TALLAWONG STATION **PRECINCT SOUTH**

ADDENDUM URBAN DESIGN REPORT

Rev. E_10.12.2020

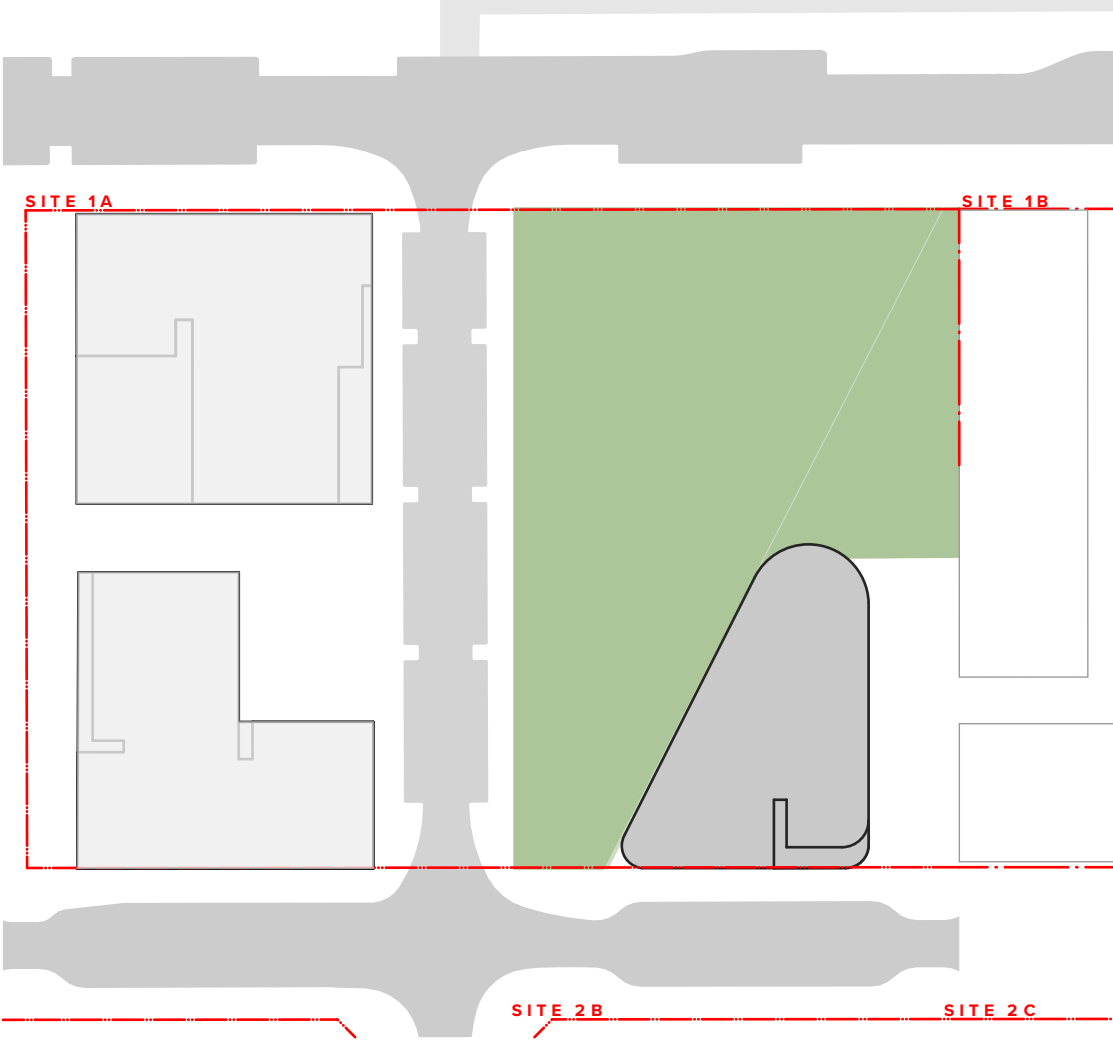
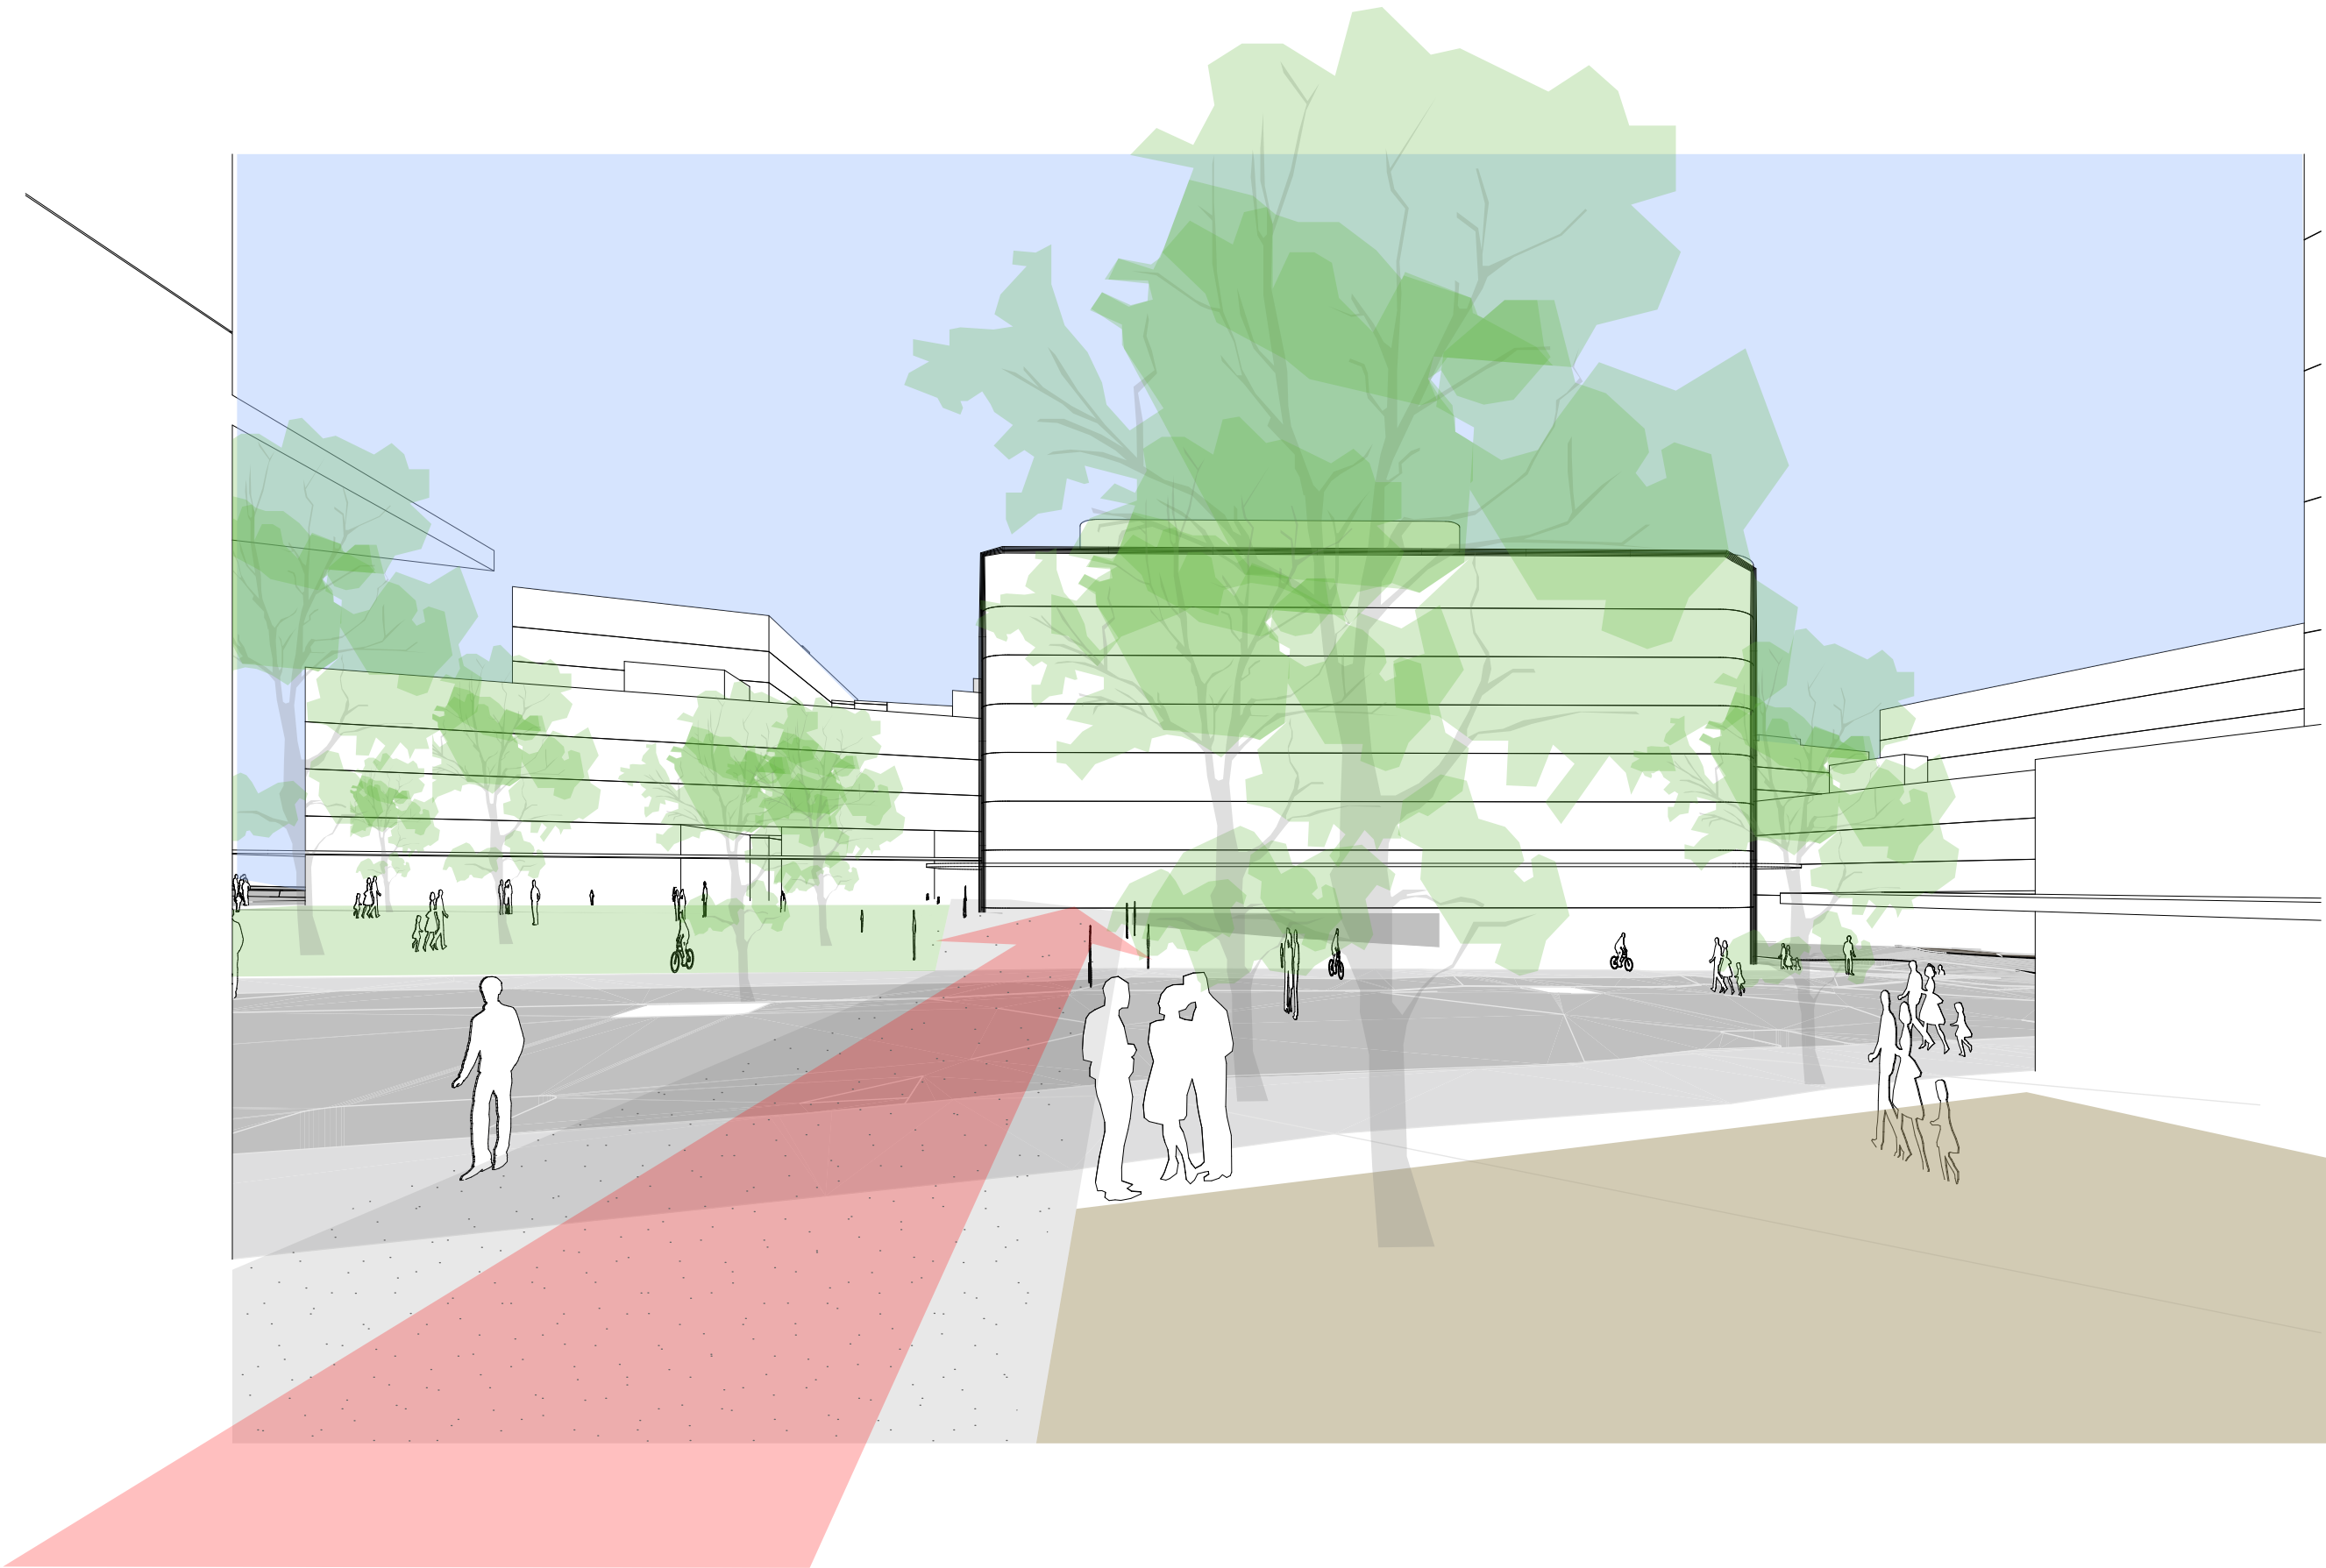
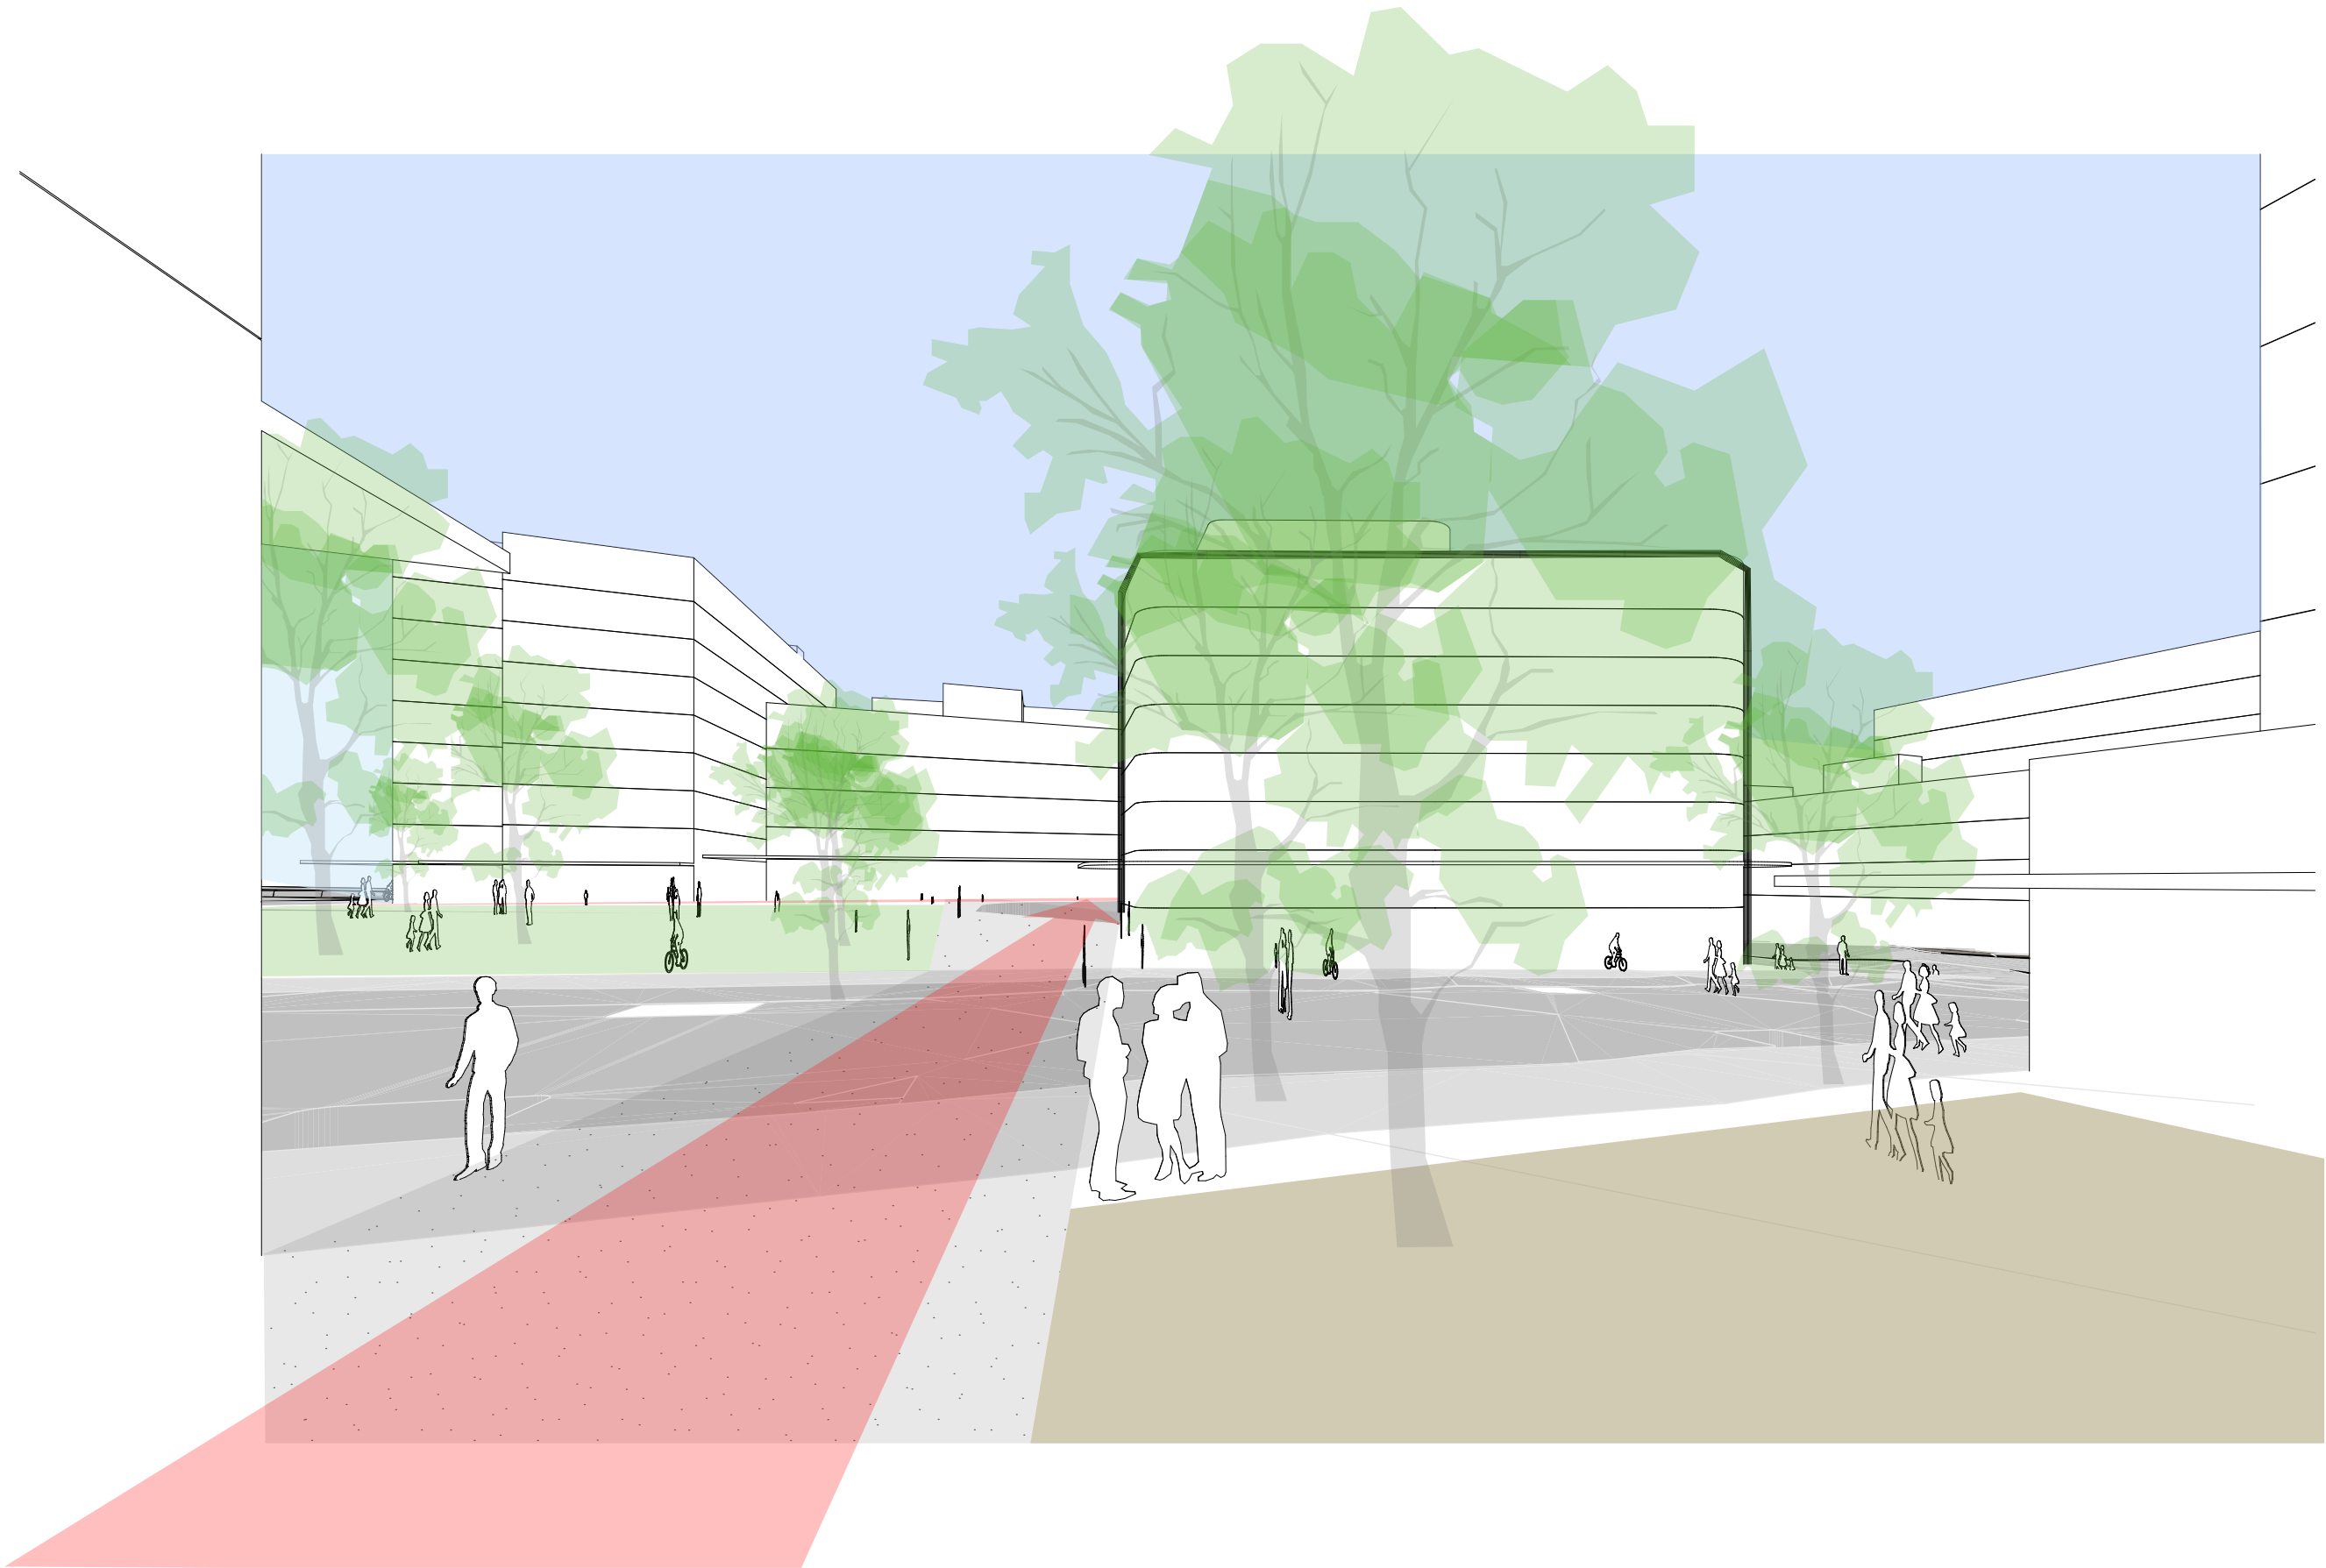
- ✓ Reduce building footprint to object building to provide a direct visual and physical connection to the pedestrian boulevard from commuter carpark, increasing the size of the public park
